MIL-R-49209A(CR)
AMENDMENT-1
29 December 1986

MILITARY SPECIFICATION
RADIO TERMINAL SET
AN/TRC-173

This amendment forms a part of military specification MIL-R-49209A, dated 8 February 1985, and is approved for use within the Communications-Electronics Command, Department of the Army and is available for use by all Departments and Agencies of the Department of Defense.

RADIO OPERATION
FIGURE 1

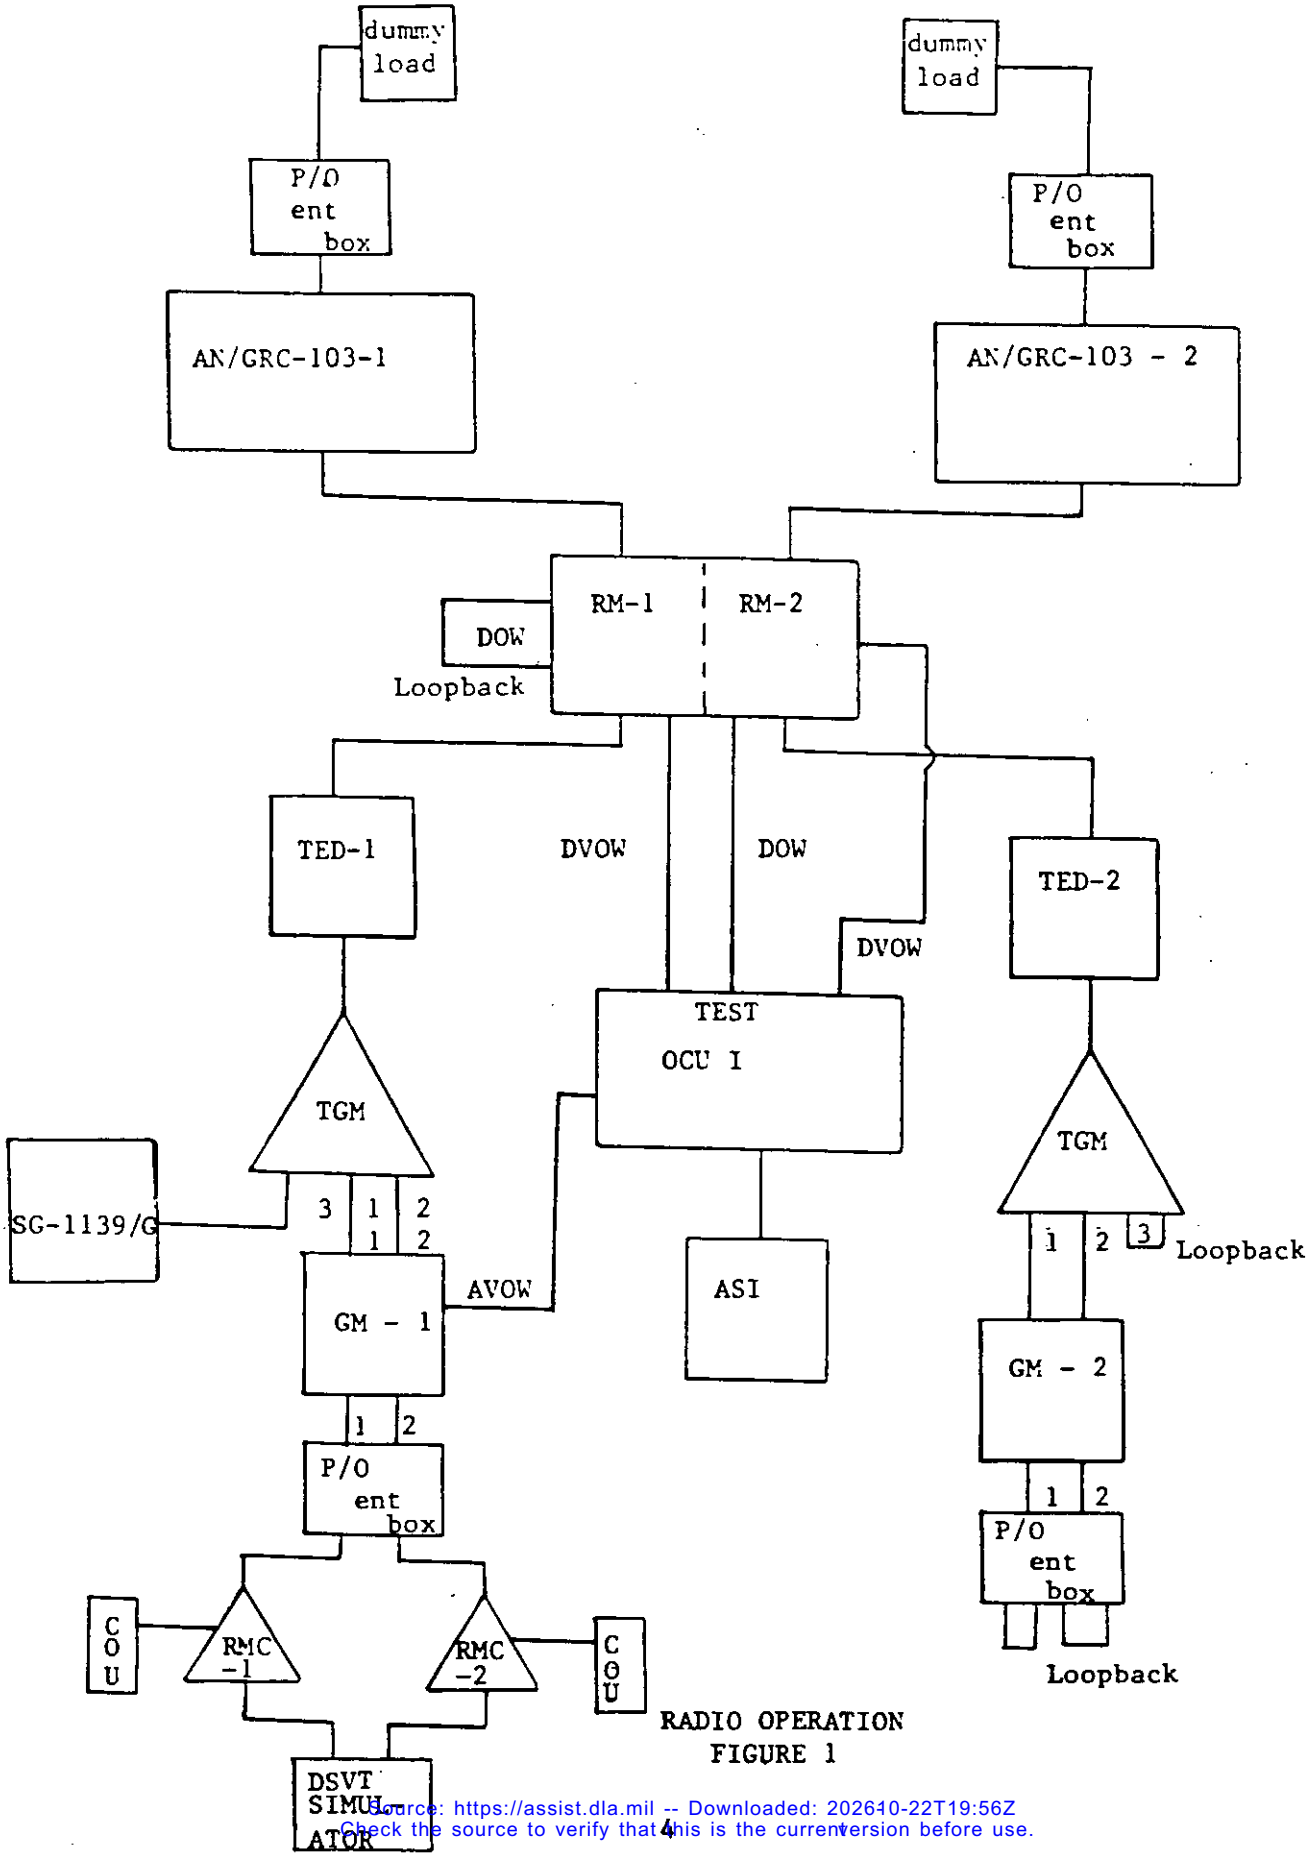
a. Interconnect equipment as shown in Figure 1. Testing shall be performed at a super group rate of 1152 kb/s.

Figure 1 - Delete and substitute attach figure 1.

CABLE OPERATION
FIGURE 2

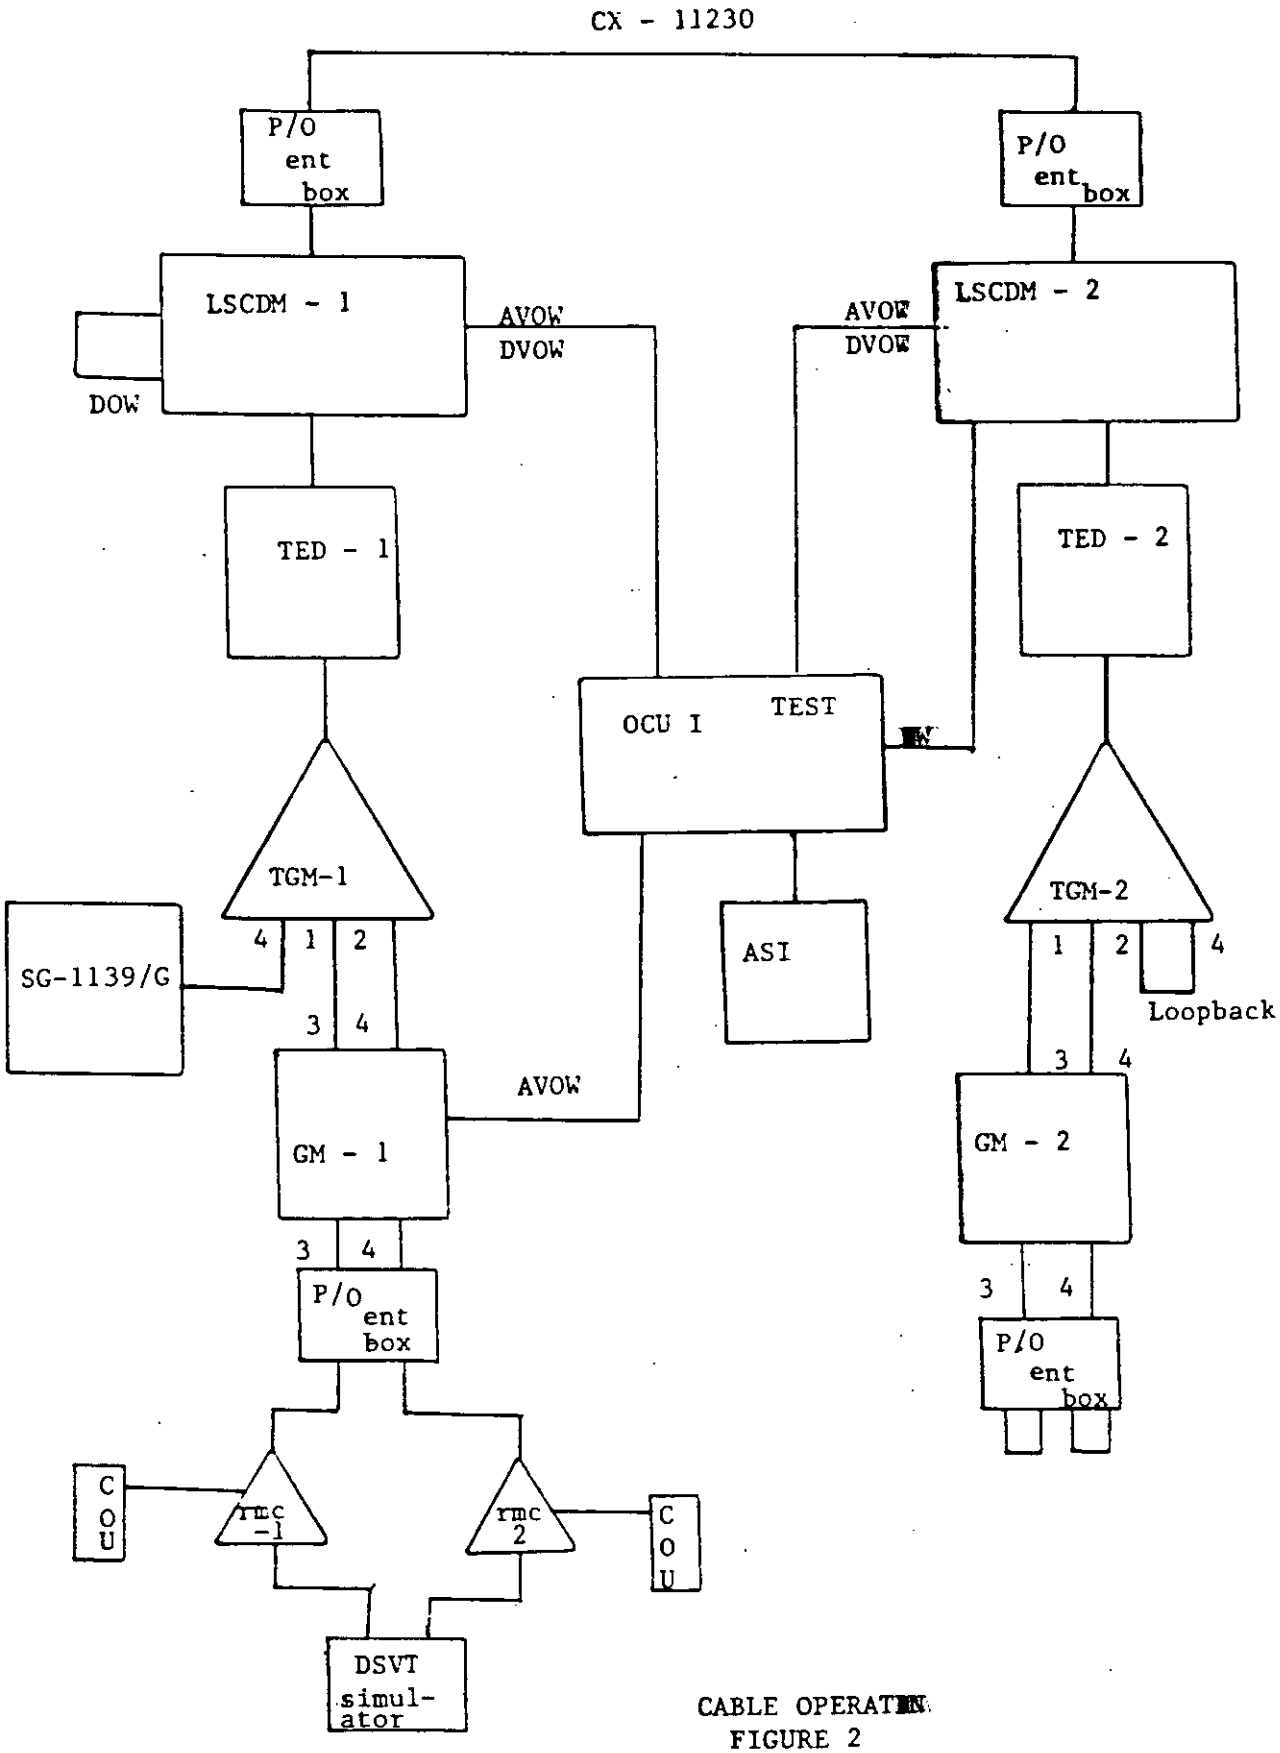
i. Replace the radio modem and radios with LSCDMs (fig 2) and perform testing of paragraphs c thru g."

Figure 2 - Delete and substitute attach figure 2.

RLGM/CD - RADIO OPERATION
FIGURE 3

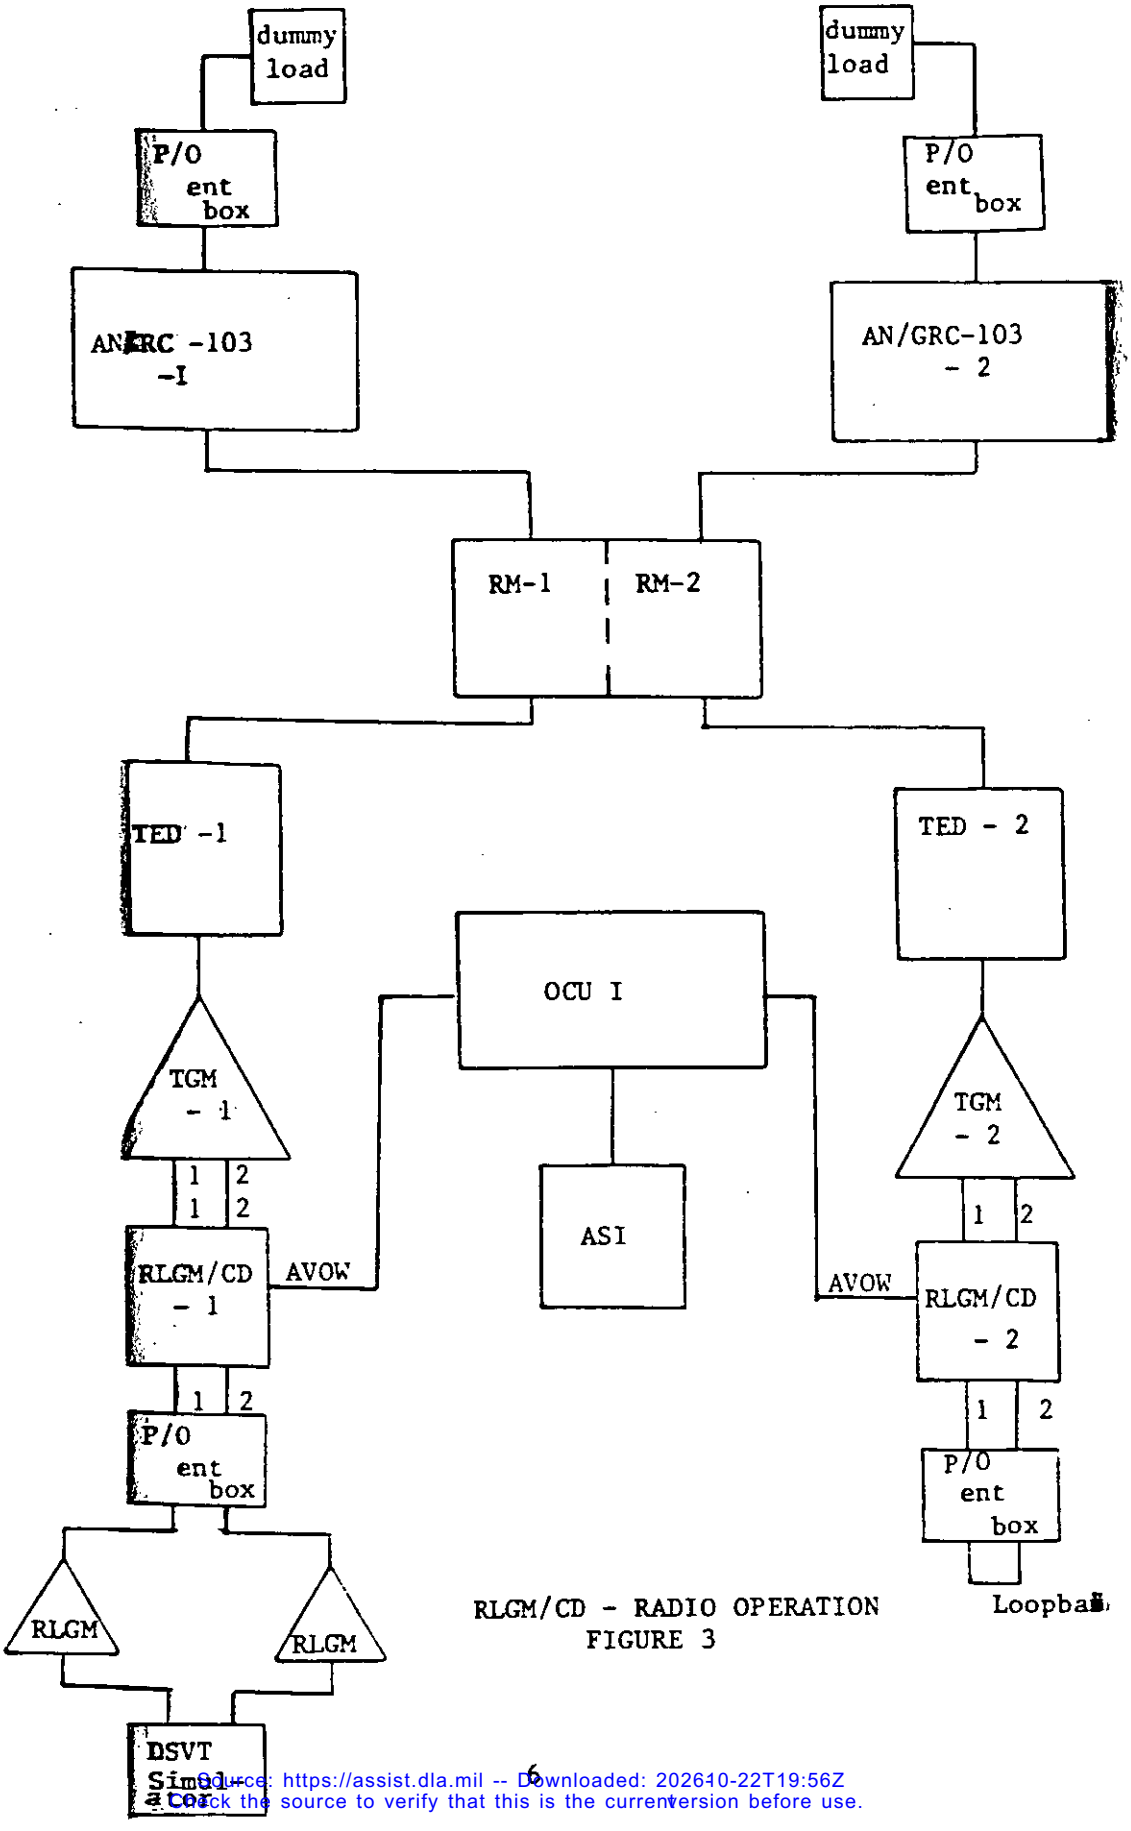
a. Interconnect equipment as shown in Fig 3. Testing shall be performed at a super group rate of 288 kb/s.

Figure 3 - Delete and substitute attach figure 3.
